CALIFORNIA COASTAL COMMISSION

STAFF REPORT: PERMIT AMENDMENT

Application No.:	4-04-077-A6
Applicant:	Rancho Mar, LLC
Agent:	Anne Blemker, McCabe & Company, Inc.
Project Location:	Approximately one mile west of Malibu Canyon Road and 1.5 miles north of Pepperdine University, Santa Monica Mountains, Los Angeles County (Related APNs: 4457-002-040, 4457-002-045, 4457-002-044, 4457-004-050, 4457-004-047, 4457-004-049, 4457-004-048, 4457-004-016, 4457-004-015).
Description of Original Project Approved on April 13, 2005:	Construction of a three story, 34 foot high, 9,385 sq. ft. single family residence, 1,017 sq. ft. three car attached garage, swimming pool, septic system, driveway, water wells and tanks, and 2100 cu. yds. of grading (2000 cu. yds. cut, 100 cu. yds. fill). The proposed project also includes improvements, and turnarounds, relocation of an approximately 700 foot long section of the road, and approximately 30,695 cu. yds. of grading (15,085 cu. yds. cut, 15,610 cu. yds. fill). The project also includes a request for after-the fact approval of unpermitted development consisting of an approximately 370 foot long section of road. See Appendix B for descriptions of previous pe

Exhibit 4
CDP 4-04-077-A6
Project Plans

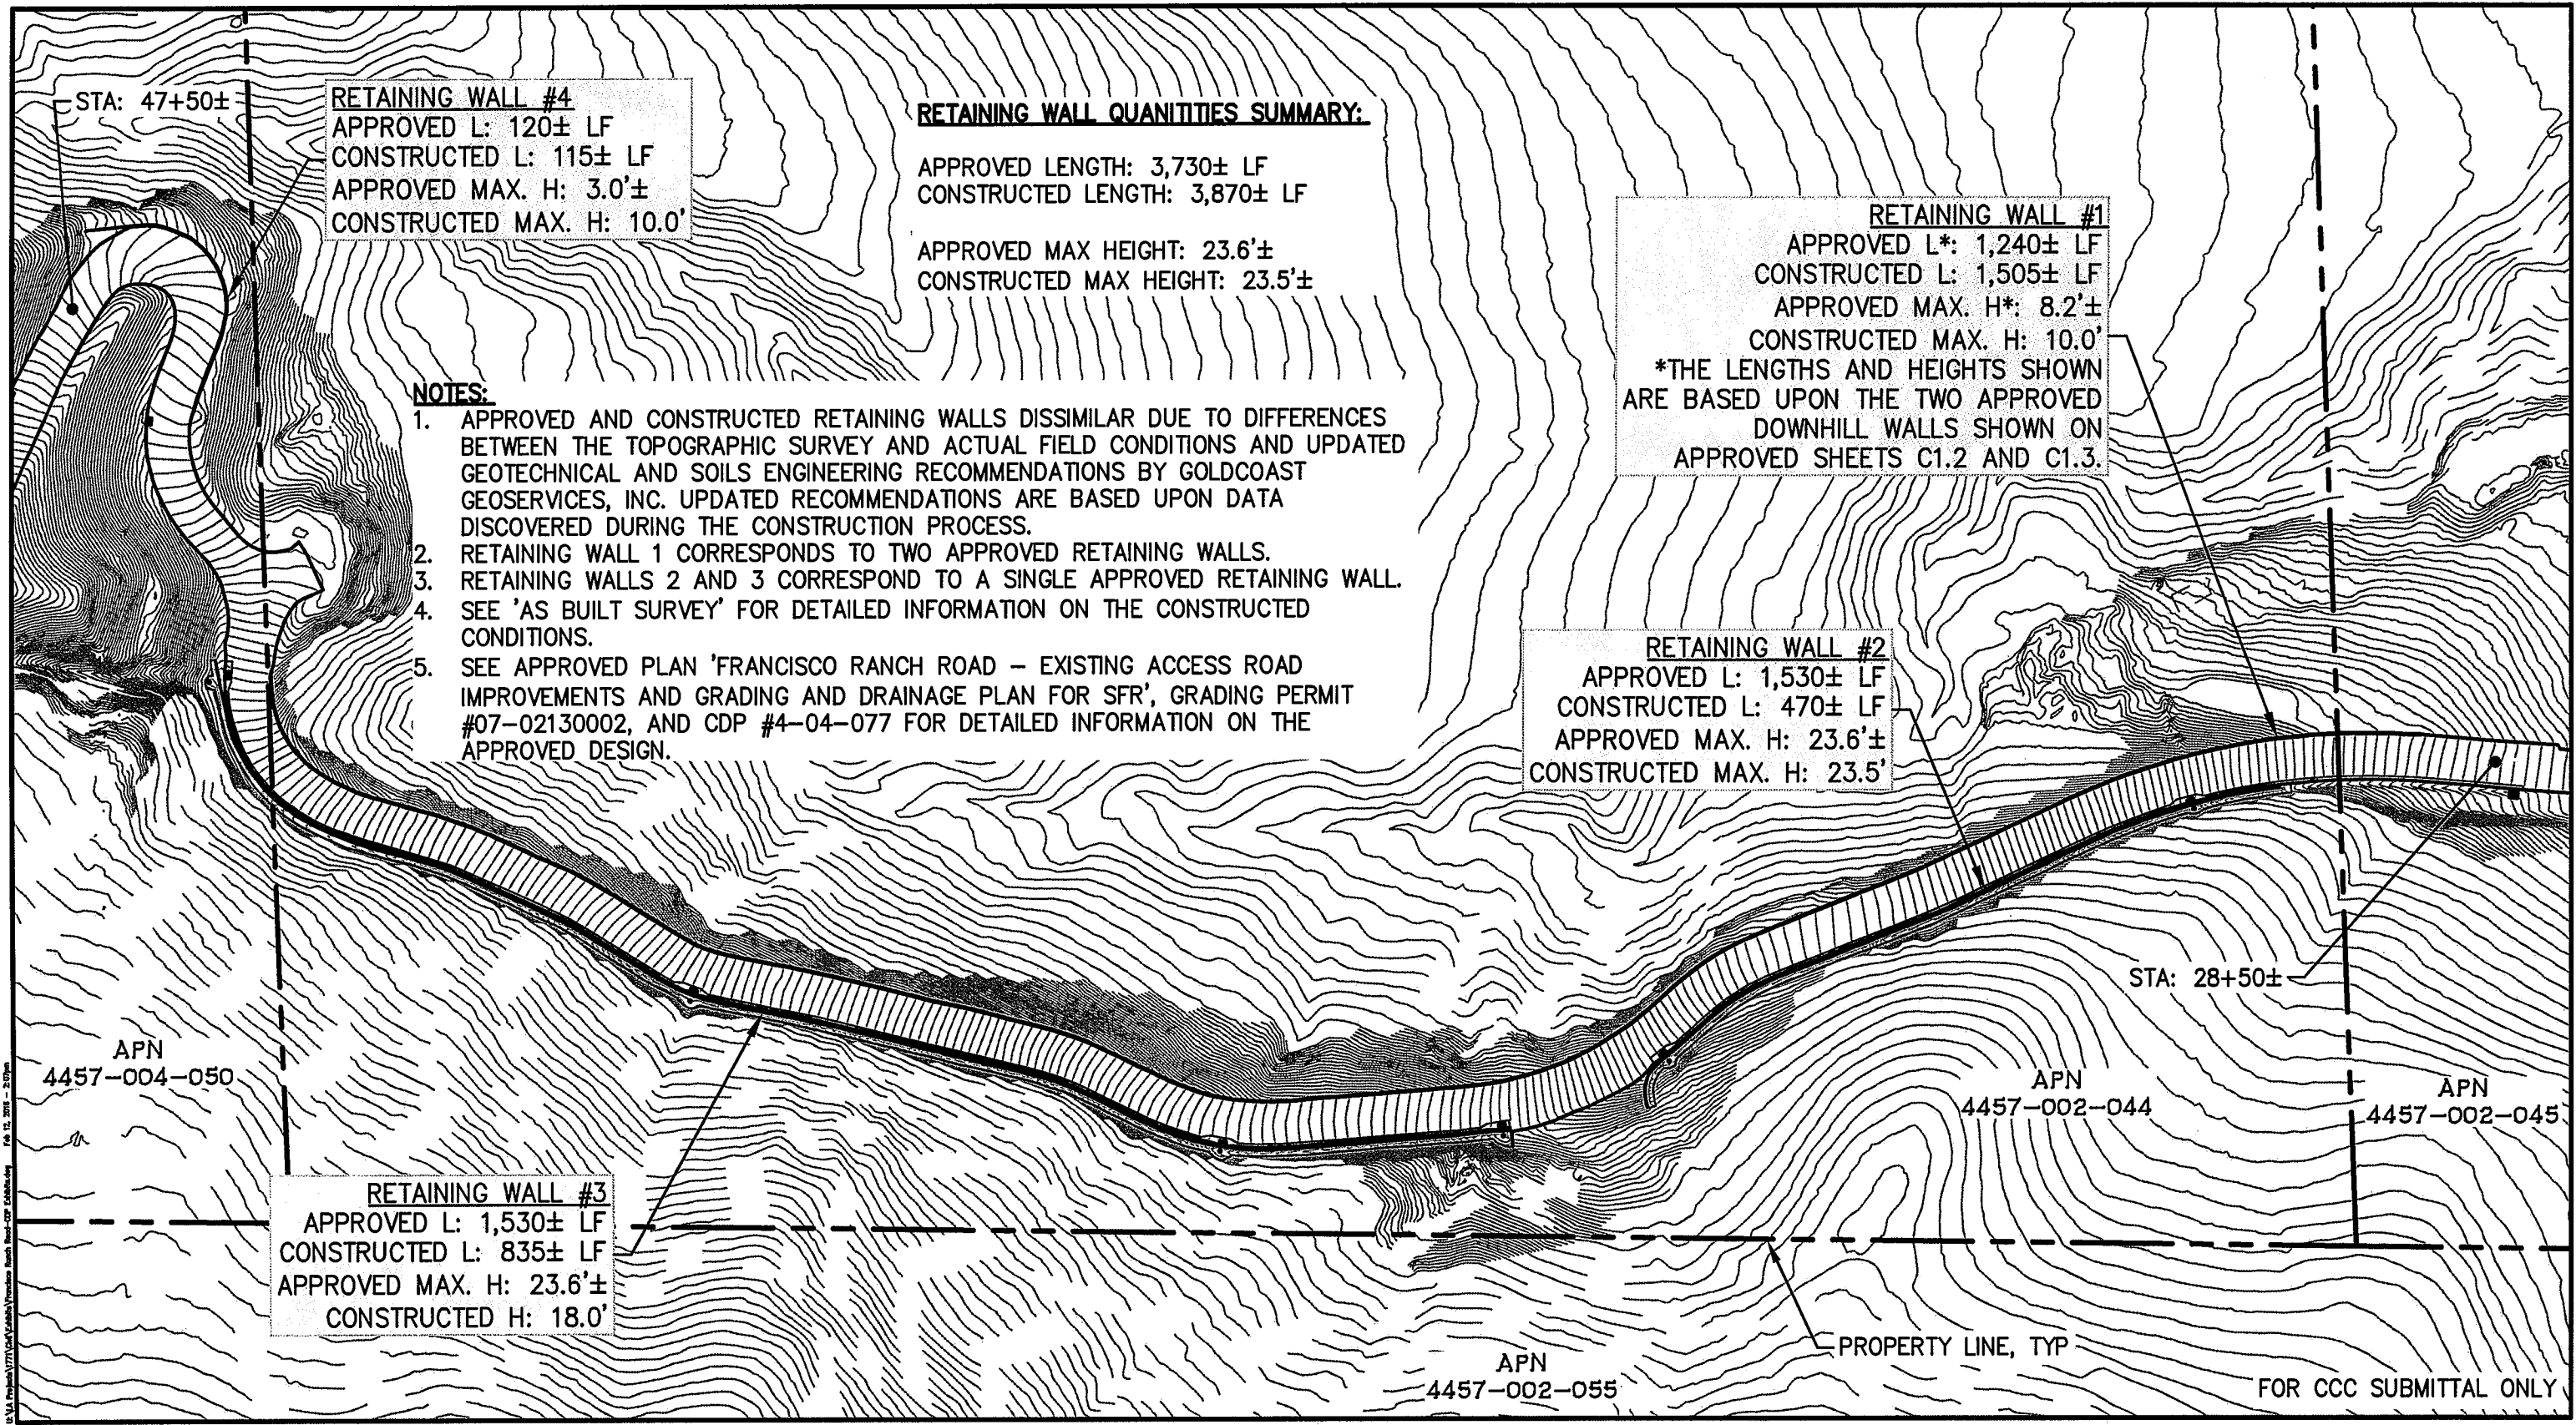
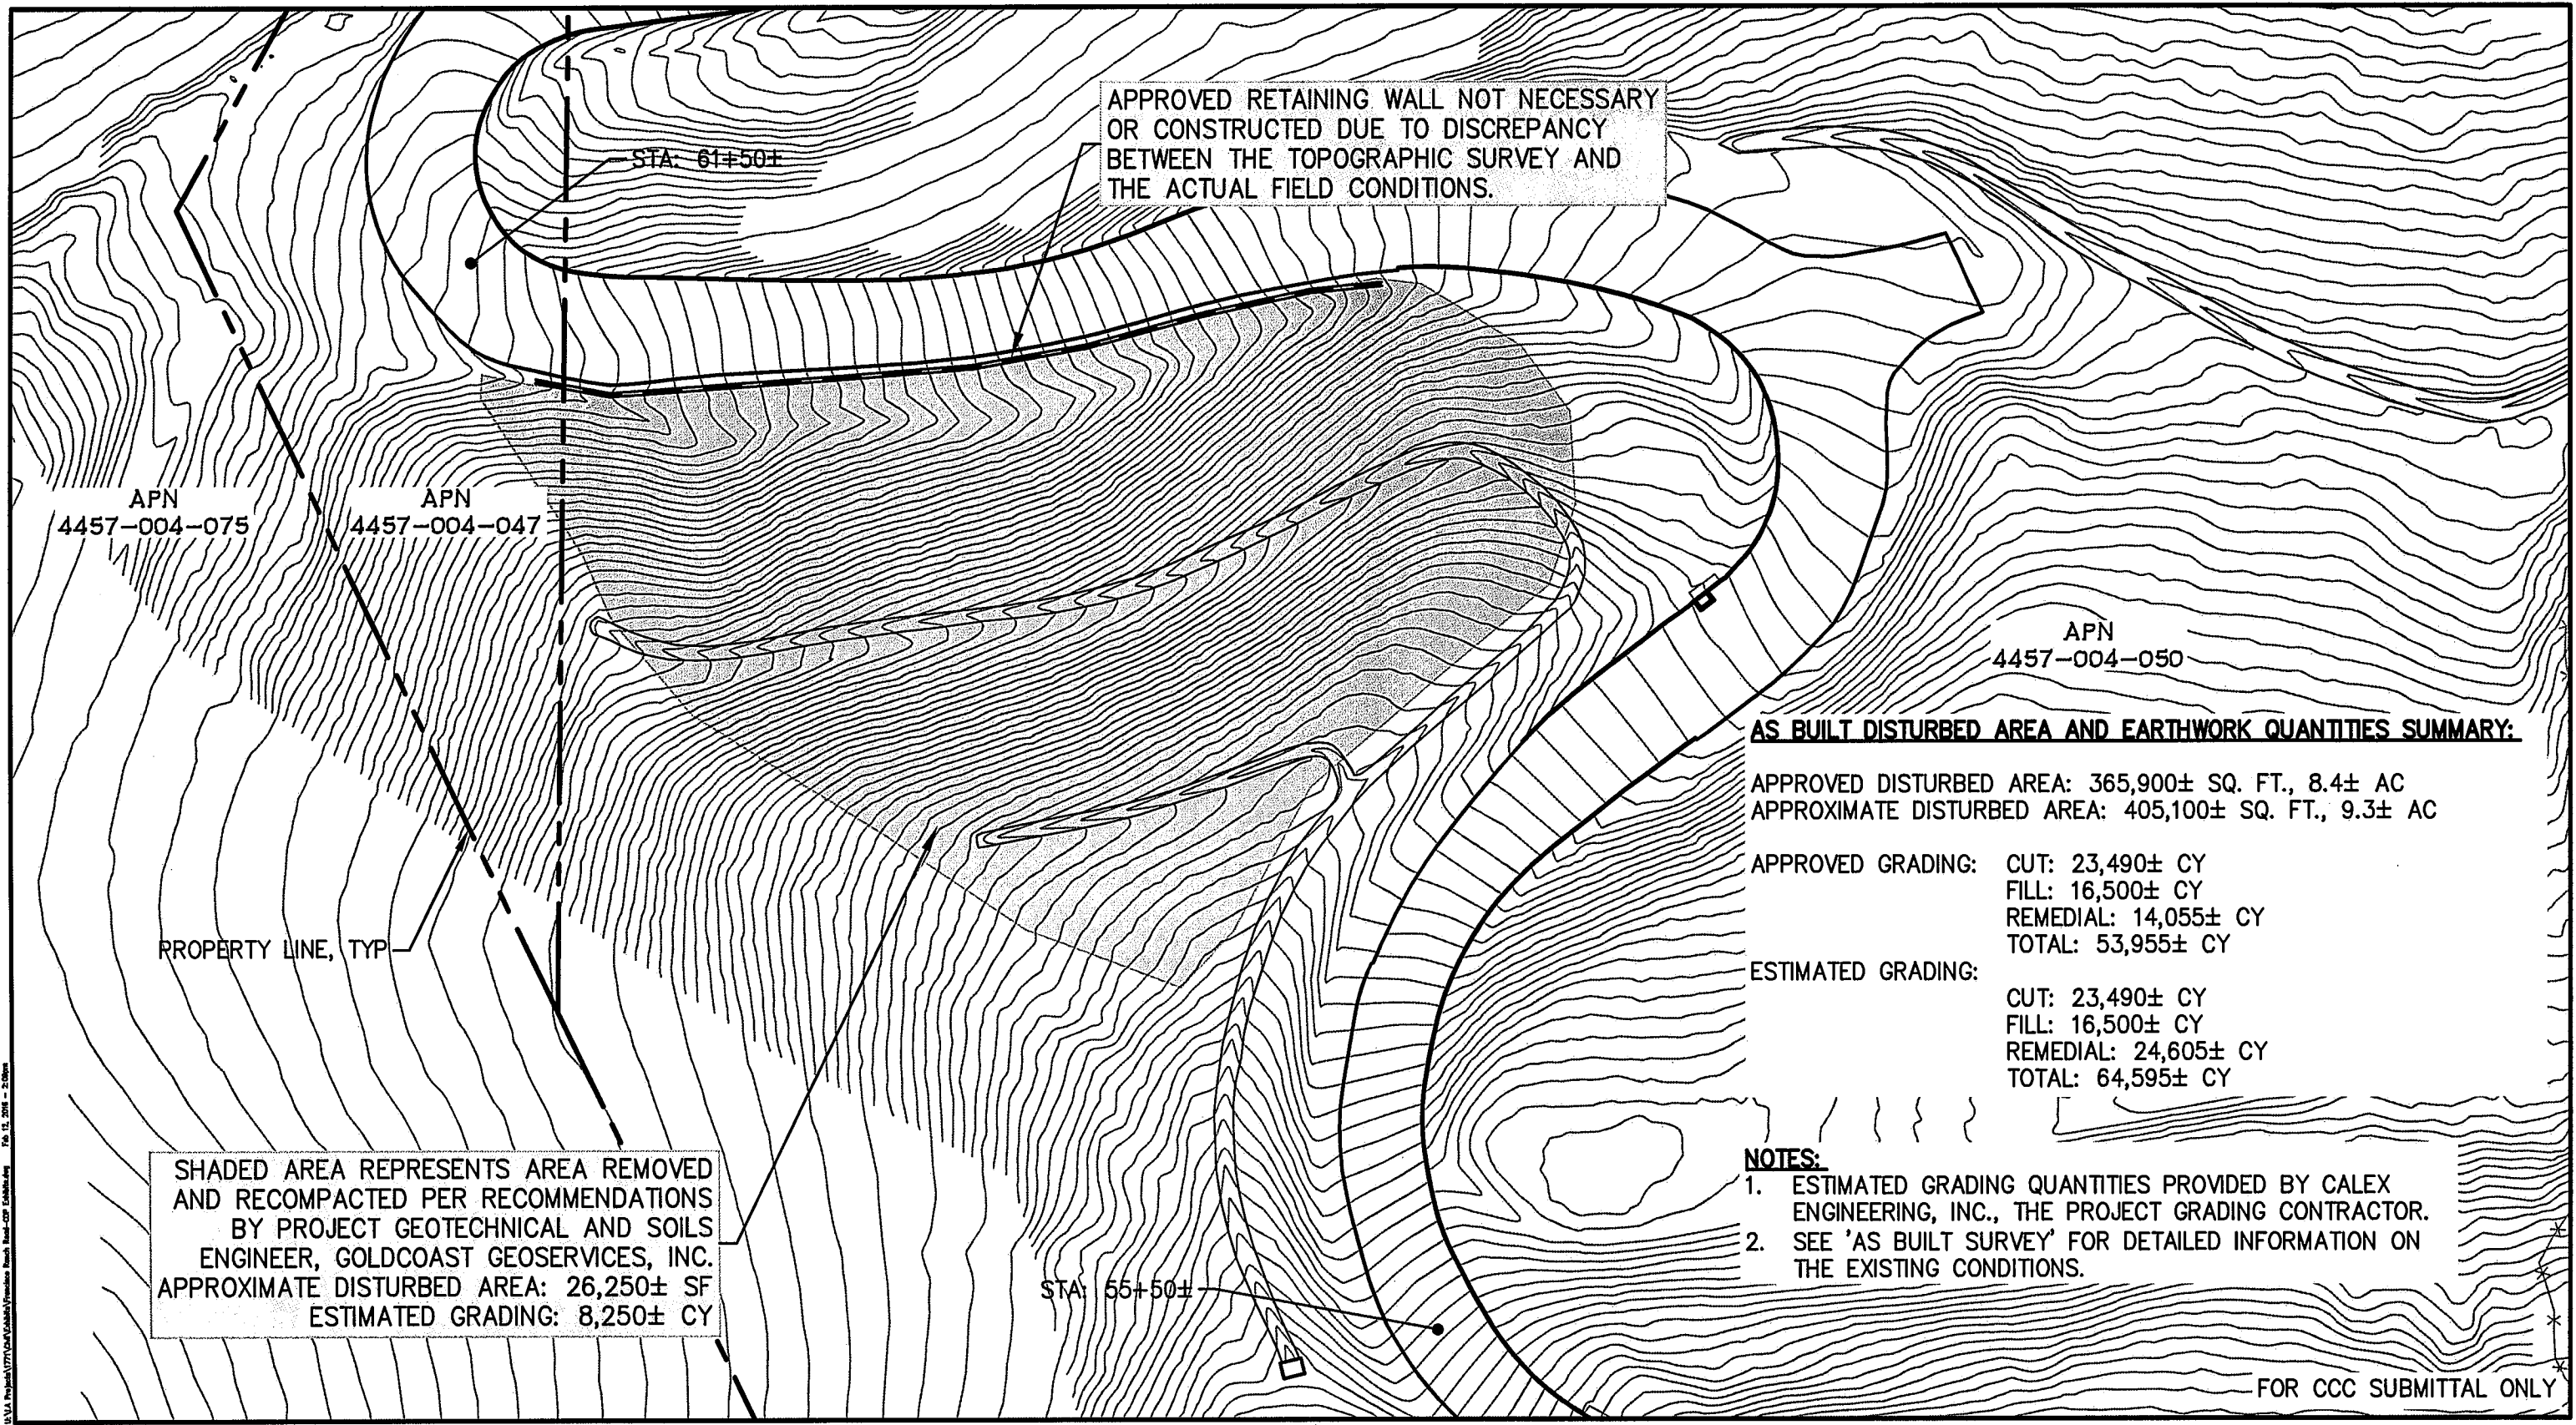
RETAINING WALL #4
 APPROVED L: 120± LF
 CONSTRUCTED L: 115± LF
 APPROVED MAX. H: 3.0'±
 CONSTRUCTED MAX. H: 10.0'

APPROVED MAX HEIGHT: 23.6'±
 CONSTRUCTED MAX HEIGHT: 23.5'±

RETAINING WALL #1
 APPROVED L*: 1,240± LF
 CONSTRUCTED L: 1,505± LF
 APPROVED MAX. H*: 8.2'±
 CONSTRUCTED MAX. H: 10.0'
 *THE LENGTHS AND HEIGHTS SHOWN
 ARE BASED UPON THE TWO APPROVED
 DOWNHILL WALLS SHOWN ON
 APPROVED SHEETS C1.2 AND C1.3.

RETAINING WALL #2
 APPROVED L: 1,530± LF
 CONSTRUCTED L: 470± LF
 APPROVED MAX. H: 23.6'±
 CONSTRUCTED MAX. H: 23.5'

RETAINING WALL #3
 APPROVED L: 1,530± LF
 CONSTRUCTED L: 835± LF
 APPROVED MAX. H: 23.6'±
 CONSTRUCTED H: 18.0'

RETAINING WALL #6
 APPROVED L*: 160± LF
 CONSTRUCTED L: 420± LF
 APPROVED MAX. H*: 10.4'±
 CONSTRUCTED MAX. H: 17.7'±
 *THE LENGTHS AND HEIGHTS SHOWN ARE BASED UPON THE TWO APPROVED UPHILL WALLS SHOWN ON APPROVED SHEET C1.6.

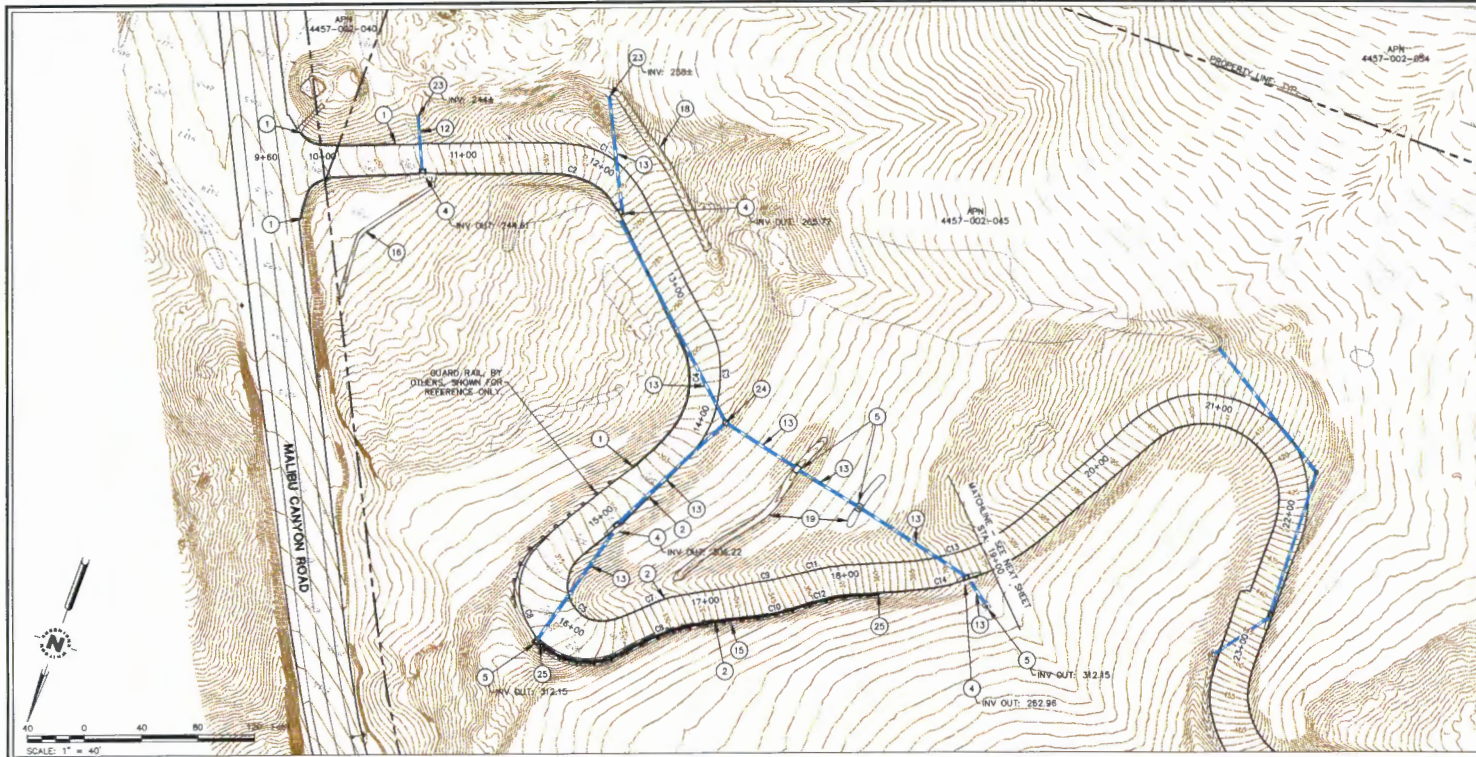
ESTIMATED GRADING: CUT: 23,490± CY
 FILL: 16,500± CY
 REMEDIAL: 24,605± CY
 TOTAL: 64,595± CY

SHADED AREA REPRESENTS AREA REMOVED AND RECOMPACTED PER RECOMMENDATIONS BY PROJECT GEOTECHNICAL AND SOILS ENGINEER, GOLDCOAST GEOSERVICES, INC. APPROXIMATE DISTURBED AREA: 11,250± SF ESTIMATED GRADING: 1,900± CY
